CITY OF LONG BEACH

CHAIR AND CULTURAL HERITAGE COMMISSIONERS
City of Long Beach
California

Deny a Certificate of Appropriateness request for the addition of 1,533-square-feet total (387-square-feet to the first story, and 1,146-square-feet to create a new second story) to an existing one-story, single-family residence in the Belmont Heights Historic District. The existing home is a contributing property within the Belmont Heights Historic District. (District 3)

Subject Property:
635 Loma Ave
Application No. HP18-512
Council District 3
Zoning Code : R-1-N

SECOND FLOOR PLAN

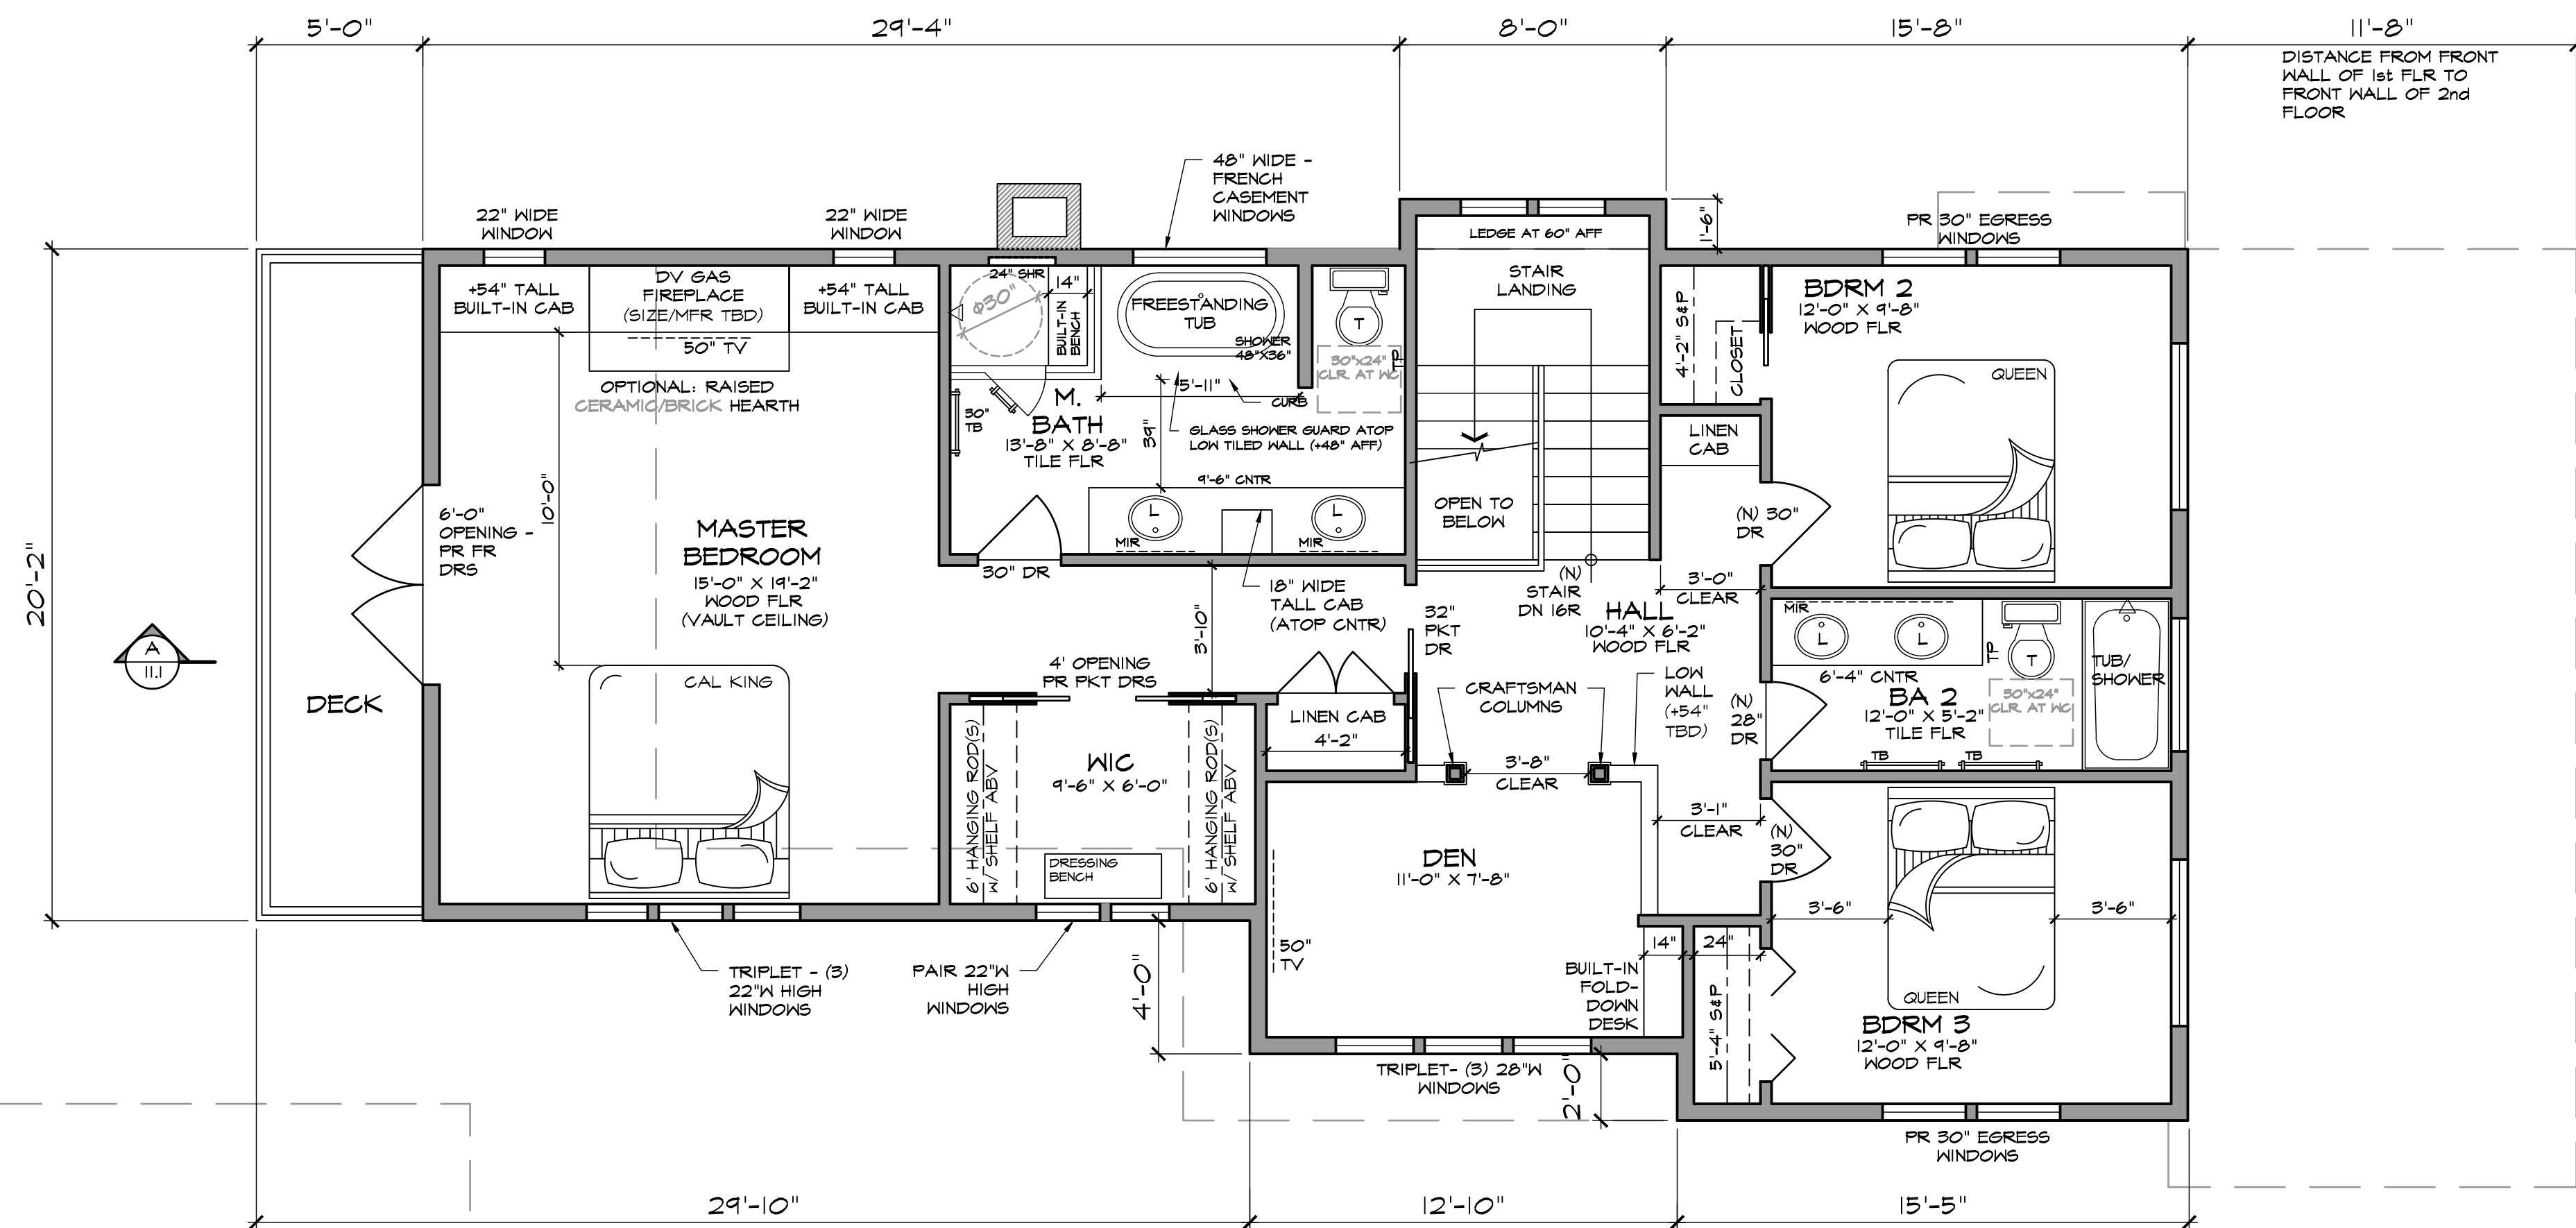
The new second story (1,146 square-feet) would be setback 32 feet from the front property line, and setback 20 feet behind the face of the existing front porch on the east elevation. The second story would align with the first-floor exterior walls on all side and rear elevations (north, south, and west elevations). Measuring from the front façade, the new second-floor addition would extend 52 feet to the rear of the home, with a second-

The proposed second story addition does not fit within the context of the historic property. While the addition to the first story (387 square-feet) does not present conflicts with the Secretary of the Interior's Standards, the massing and the visibility of the new second story (1,146 square-feet) represents a substantial change to the historic property.

ROOF PLAN

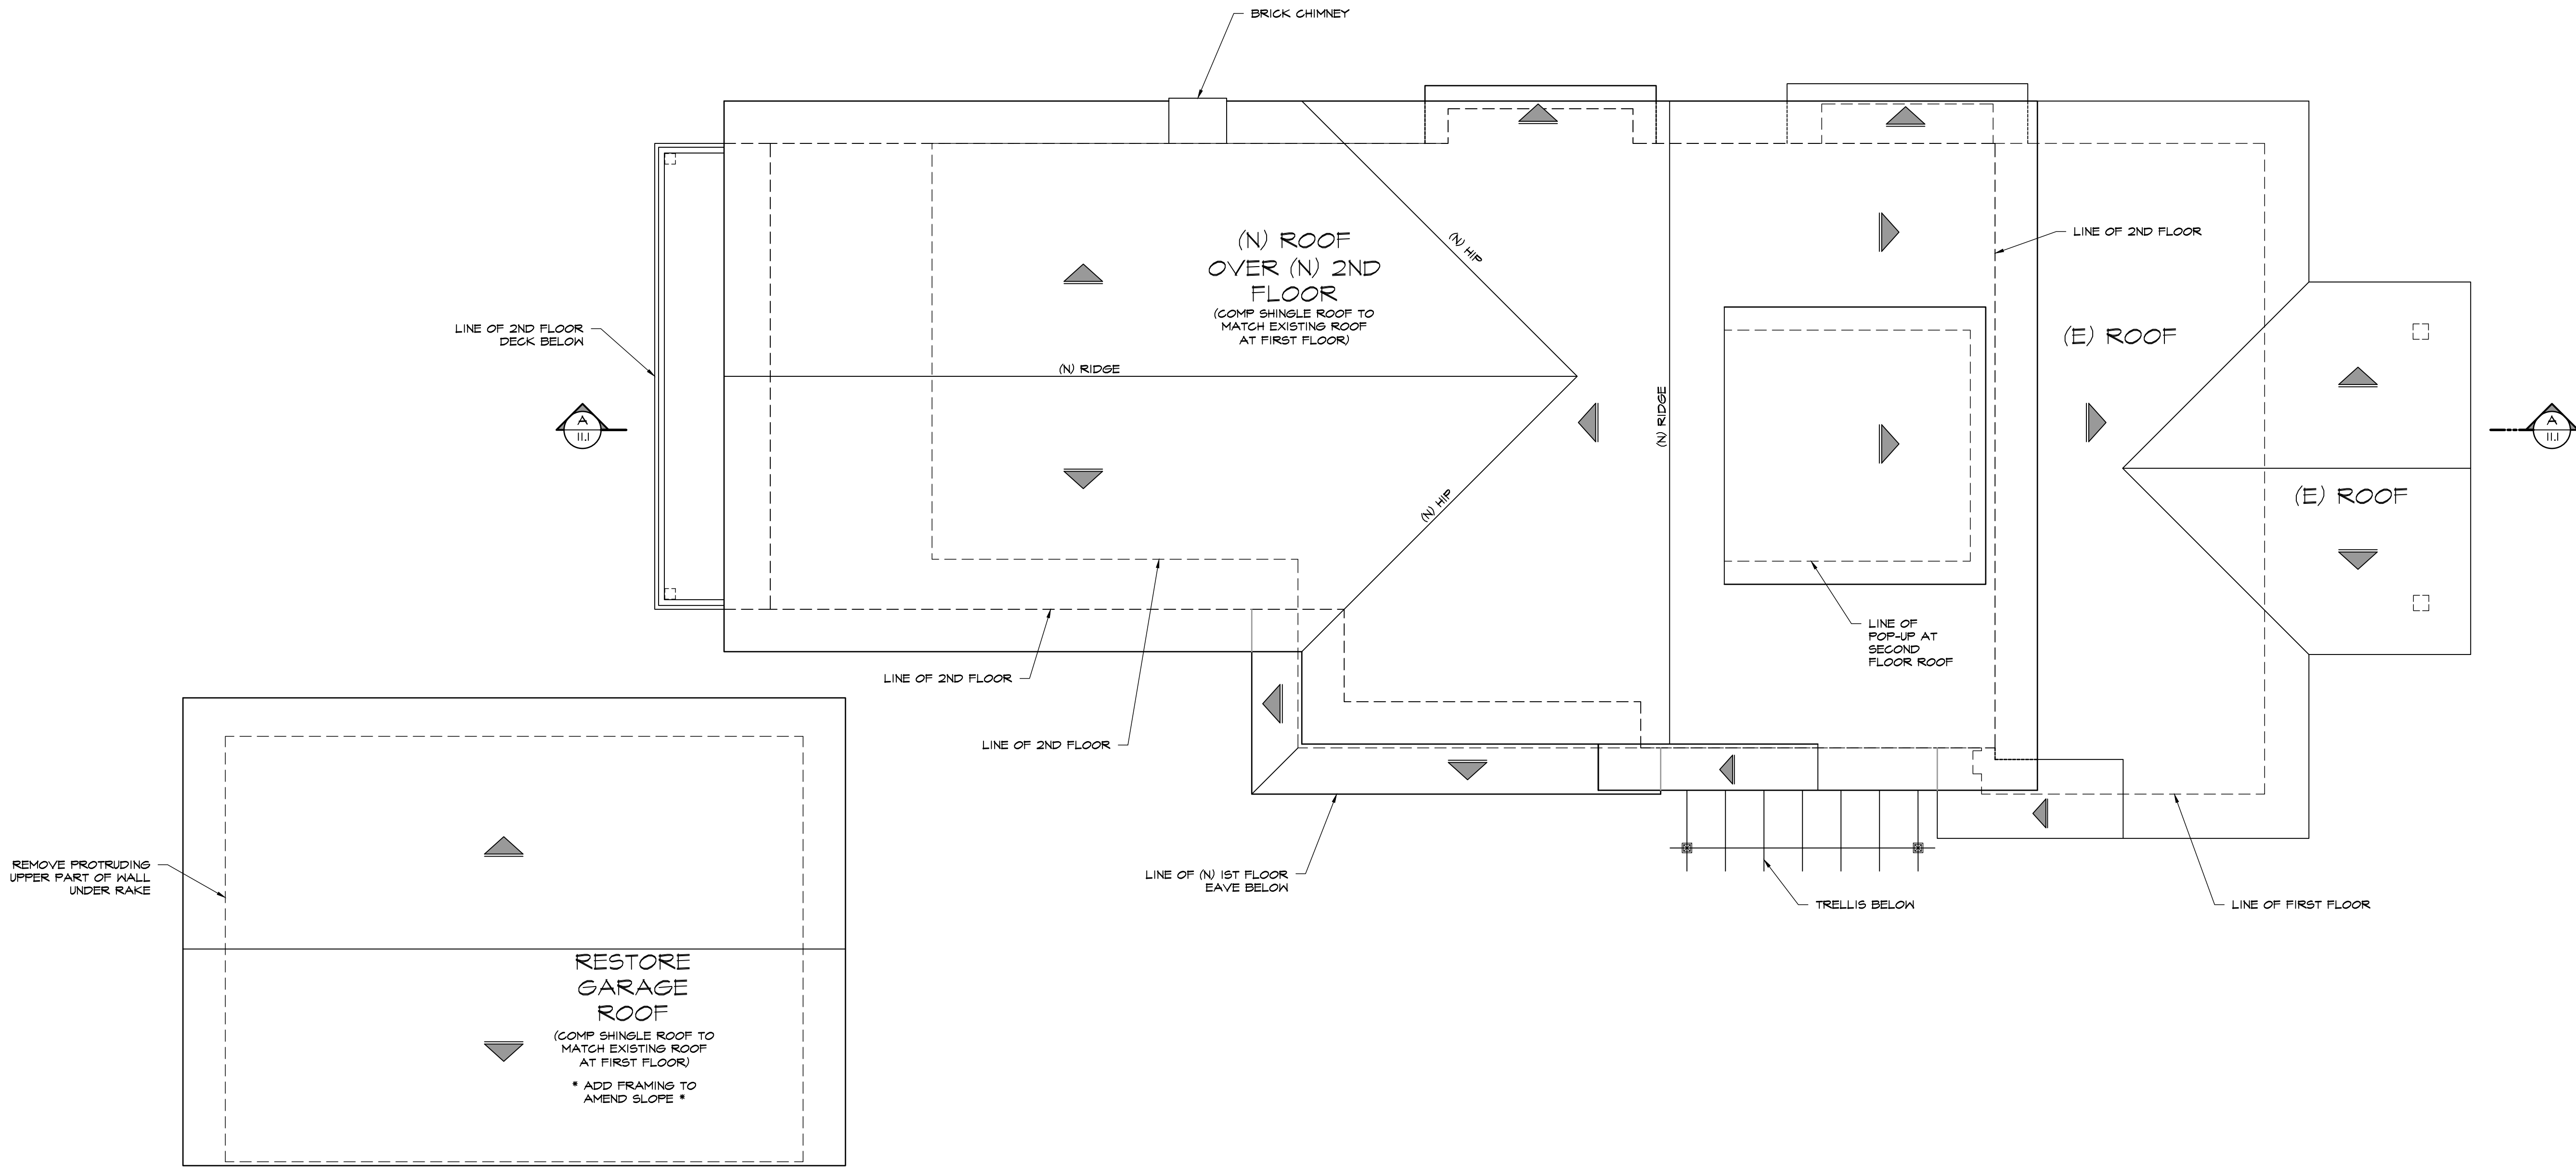
The Secretary of Interior's Standards for Rehabilitation, Standard No. 9 addresses the new additions, exterior alterations, or new construction as they relate to historic materials. The new addition will modify the historic roofline established for the property in order to accommodate the new second story. The proposed massing of the addition would diminish the historic integrity of the property and its environment.

- Distinctive Features – The proposed improvements would change the height of the existing contributing structure. The existing clipped gable roofline would be removed in order to accommodate the addition of the new second story. Furthermore, the existing historic height of the residence of 19 feet, would be increased to 25 feet on primary residence.

PROPOSED
EAST + SOUTH
EXTERIOR ELEVATIONS

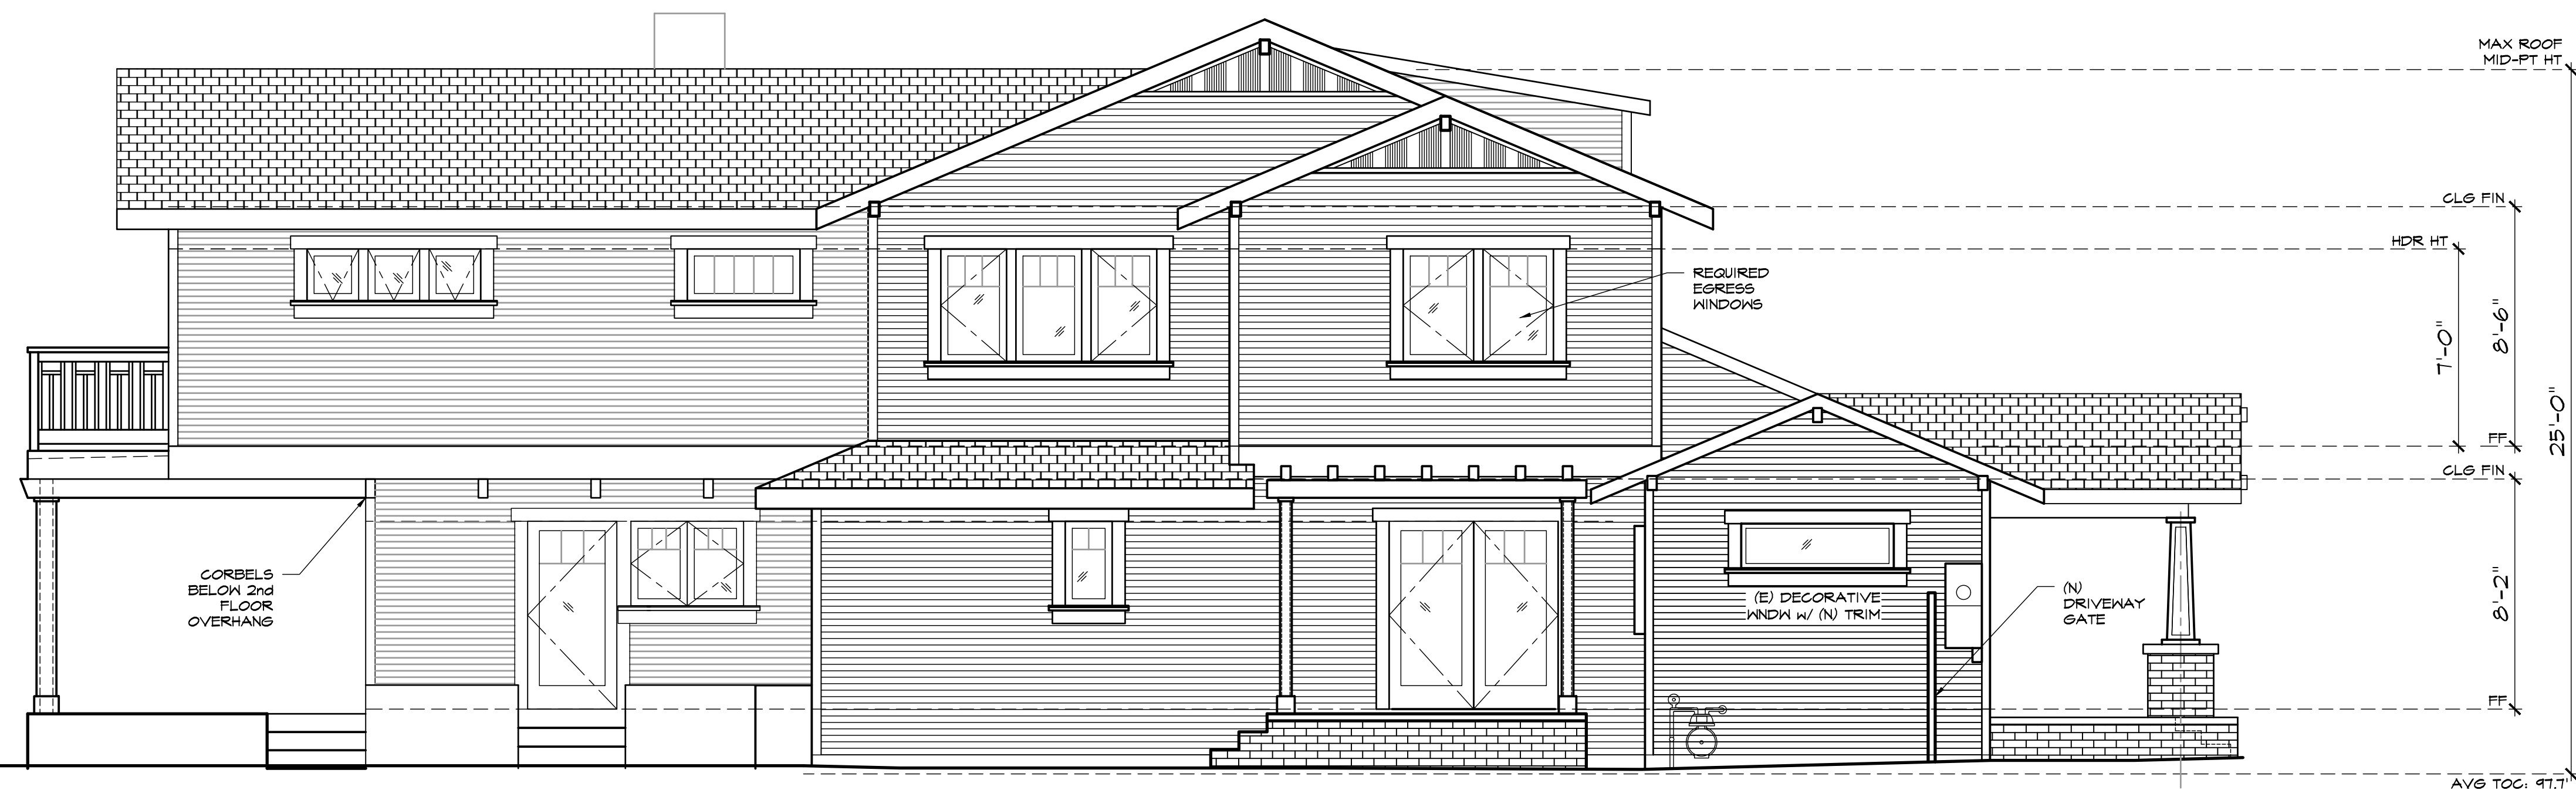
While the proposed second story would be setback from the façade and front porch of the existing primary structure, the second story addition would be highly visible from the street. As previously noted, the proposed second floor would be setback 32 feet from the front property line. Therefore, the new second story will have visual impacts when viewed from the public right-of-way on Loma Avenue. The overall height of the existing primary residence is 19-feet. The proposed second story would increase the ridge mid-point height to 25-feet in height. While 25 feet is the permitted maximum height in the R-1-N Zoning District, the proposed addition significantly alters the original building massing established for the historic property and is in conflict with the Belmont Heights Historic Landmark District Ordinance sections:

design, and shall be subordinate in scale, to the existing building.” While the new second story would incorporate a step back along the east elevation, the addition will be highly visible and would span the full width of the building. The overall massing of the proposed addition would substantially alter the context of the historic property with relation to the adjacent structures in the historic district.
